Date	Group	No.	Release	Page
10.2017	237	020	03	1(1)

Unit Injector Yoke Hold-Down Bolt Torque Specification

VN, VHD, VAH, VT

FSB 237-020, Unit Injector Yoke Hold-Down Bolt Torque Specification

Unit Injector Yoke Hold-Down Bolt Torque Procedure

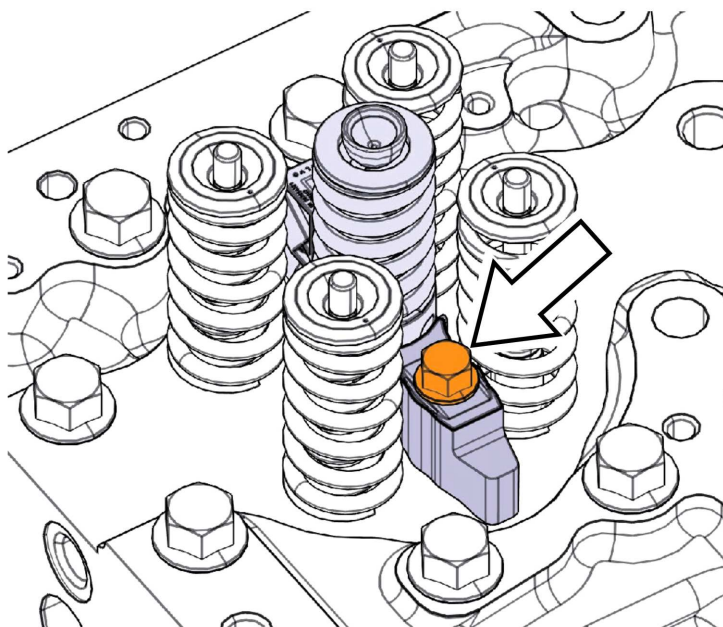
VOLVO VN, VHD, VAH, and VT trucks built from 2009 to 2017 and equipped with 11, 13, and 16 liter engines (EM-USA10, EM-USA14, and EM-USA17), will require a new torque specification for the Unit Injector Yoke Hold-Down Bolt. Effective immediately, the torque value in step 4 has changed to 25 +5/-0 Nm (18 +4/-0 ft-lb). See the torque procedure in steps 1 through 5 below. Additionally, the new yoke hold-down bolt torque will be updated in all service procedures, methods, and specification manuals.

Note: If the unit injector yoke hold-down bolts are removed, do not reuse. The unit injector yoke hold-down bolts are made for one time use only.

- 1 Tighten 20 +5 Nm (15 +4 ft-lb).
- 2 Tighten 180 ±5 degrees.
- 3 Loosen the bolt until the torque is 10 to 15 Nm (7 to 11 ft-lb), back off approximately 150 Degrees.
- 4 Tighten 25 +5/-0 Nm (18 +4/-0 ft-lb).
- 5 Tighten 90 ±5 degrees.
